: GLARESHIELD

: D3690 REVB

Job Number : 40664

D3690-041 GLARESHIELD ASSEMBLY

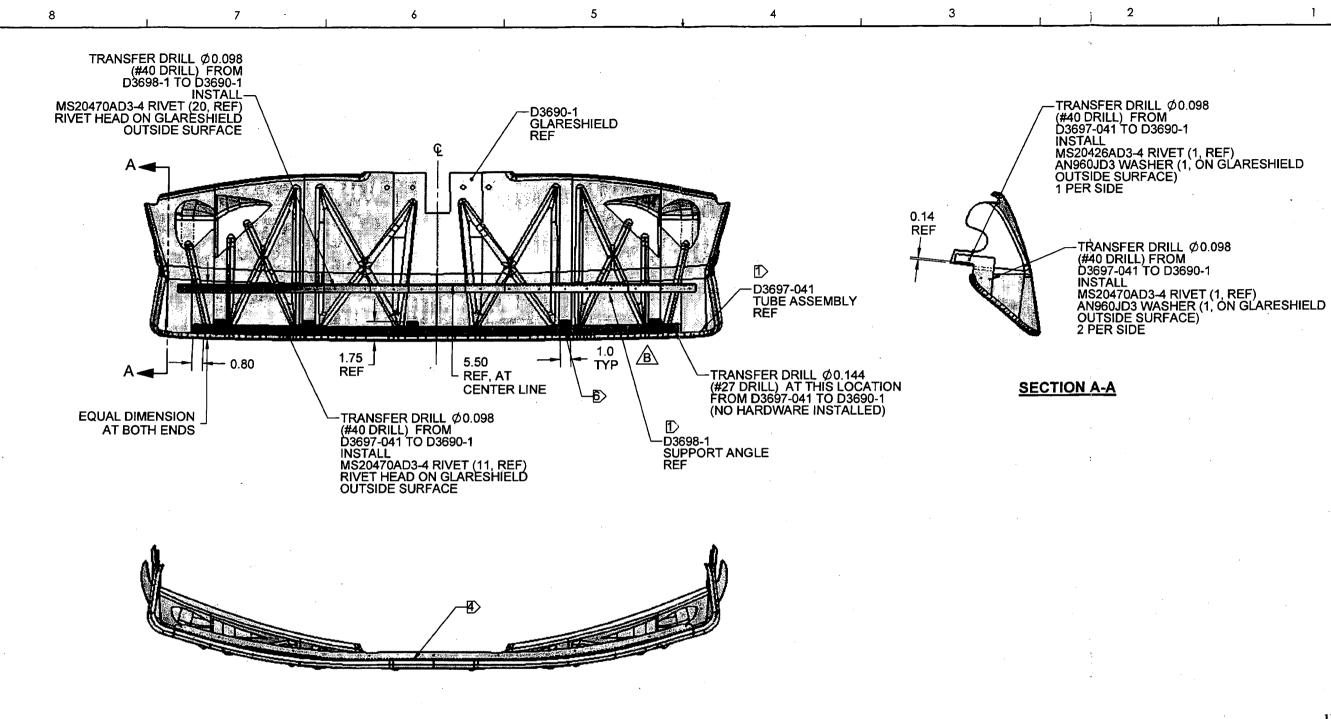
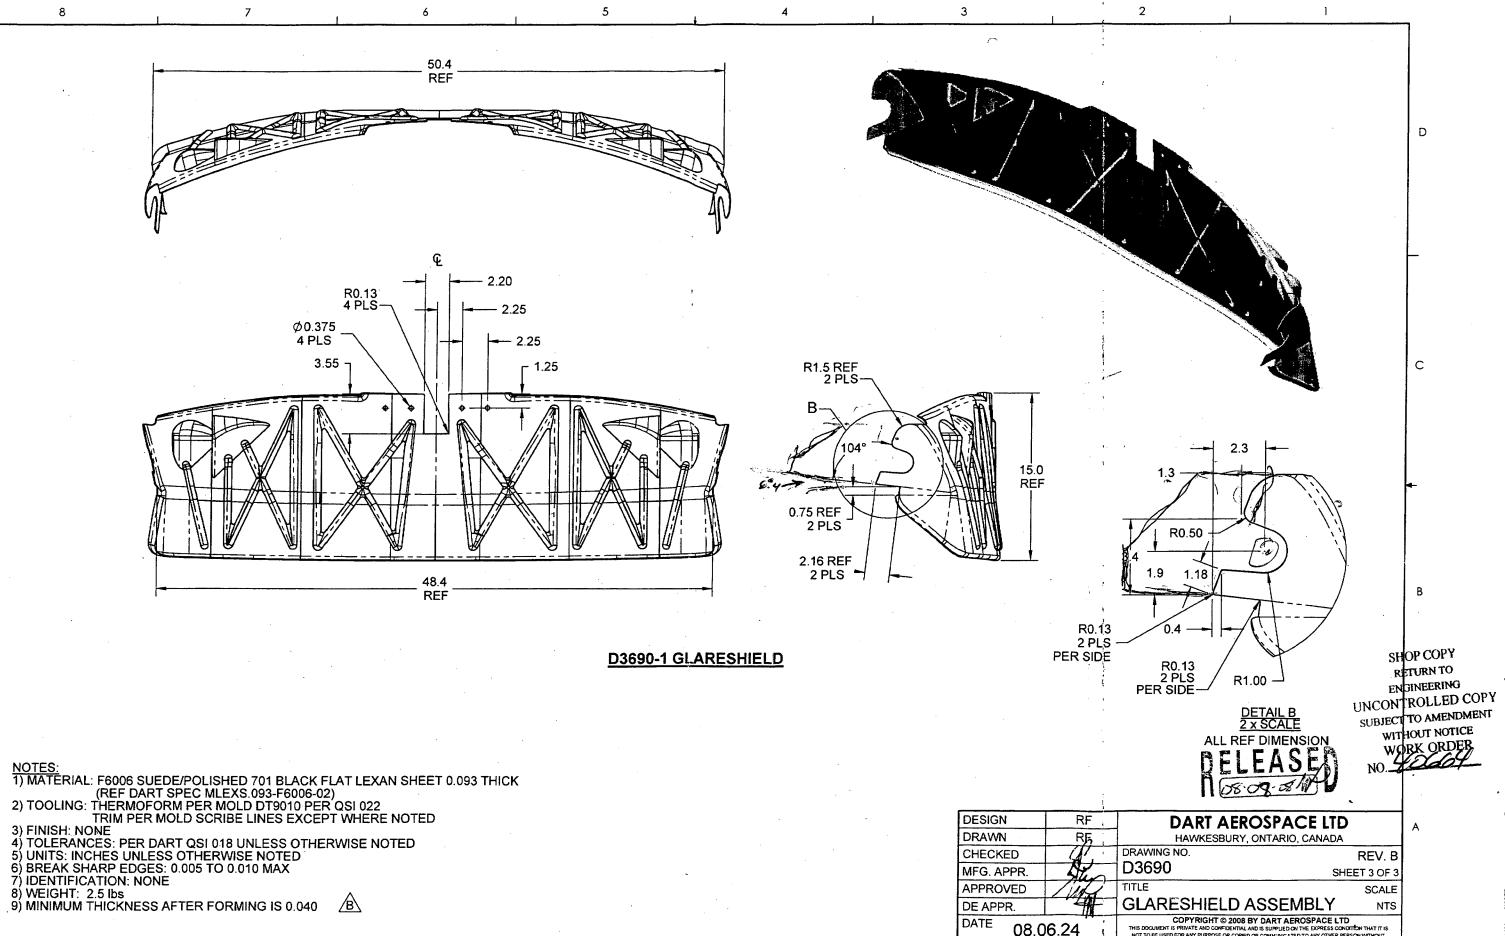
Qty(1) D3690-1 Glareshield. The cutout for the center window post, there is a 0.20" deep cut on one side of the cut-out (see pic) from the cutting tool going past the cutline. The cutout width is currently to dwg (2.20" wide).

We can widen the cutout by about $0.\tilde{2}0$ " on either side (make it symmetrical), so the final width would likely be around 2.50"-2.60" wide.

Alternately, Daryl suggested we could fill the cutout with putty because we're painting it after.

I have no QSI 042 delegation for thermoformed parts (fyi: I know Peter is always looking for more delegation). What do you think?

I am OK with the cutout being slightly wider as long as we don't run into an edge distance problem with the 4 holes that have to be drilled in that vicinity to attach the glareshield to the underlying support structure. If the edge distance looks good, go ahead and accept the modified (symmetric) glareshield.
